## **Potentially affected equipment :**

ATOM MILLENIUM type :

## **Observations :**

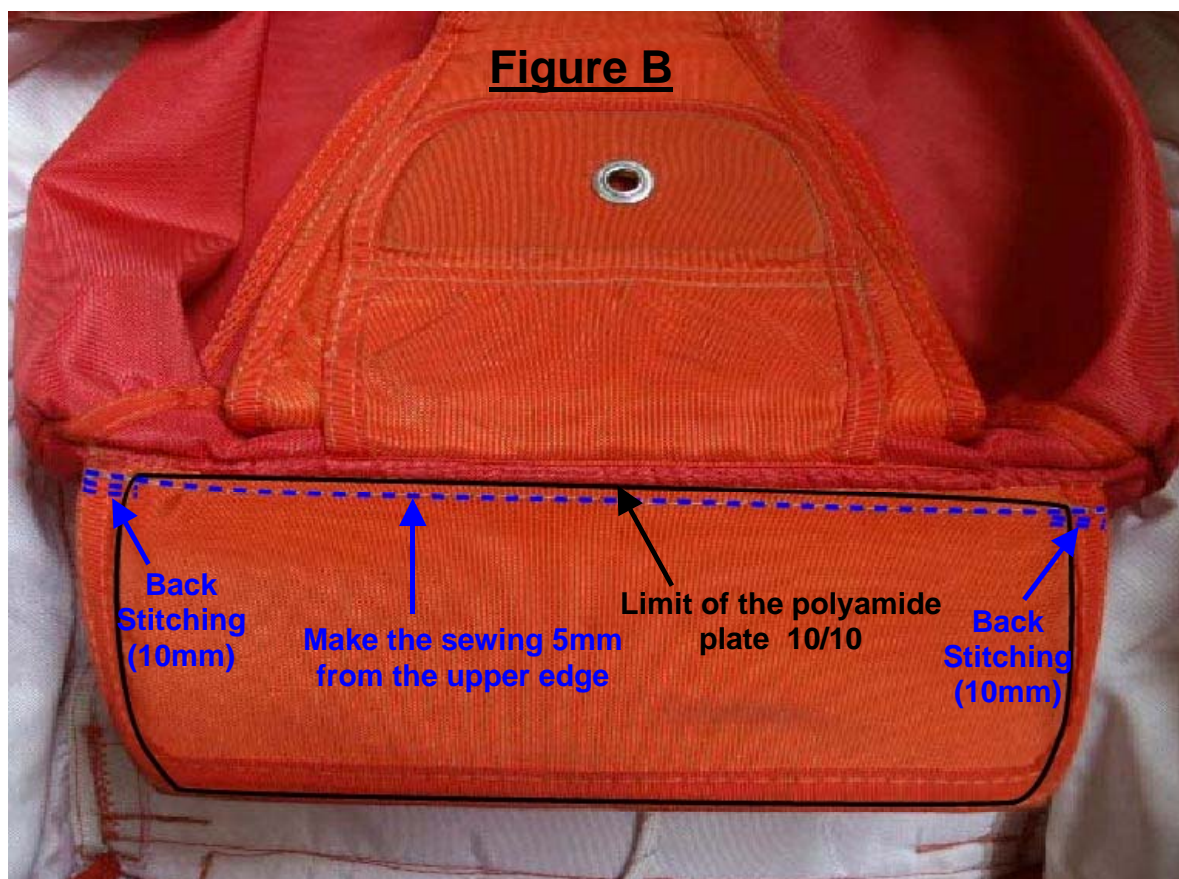
A deformation of the polyamide plate 10/10 (internal plate) of the deflector flap may occur near the sewing that binds the deflector flap to the container (see figure A).

Depending on the way the deflector flap is placed on the main deployment bag during the packing process, it may be deformed in time and its efficiency may be reduced.

**Case N°1 : In the event of a deformation as shown on figure A :** Before using the equipment again, get a qualified rigger to make a sewing on the deflector flap as shown on figure B.

Make a sewing all along the deflector flap (normal stitch) making sure that the polyamide plate 10/10 (internal plate) is included in the sewing. (The reserve canopy needs to be removed from the reserve container).

- Use polyamide thread 66 strength up to 6 kg (ref PF 9002402000 : Thread for container (30/3) or any equivalent),
- make 5 to 6 stitches every 2 cm,
- make it 5 mm from the edge,
- make two 10mm back stitching at the both ends of the sewing.
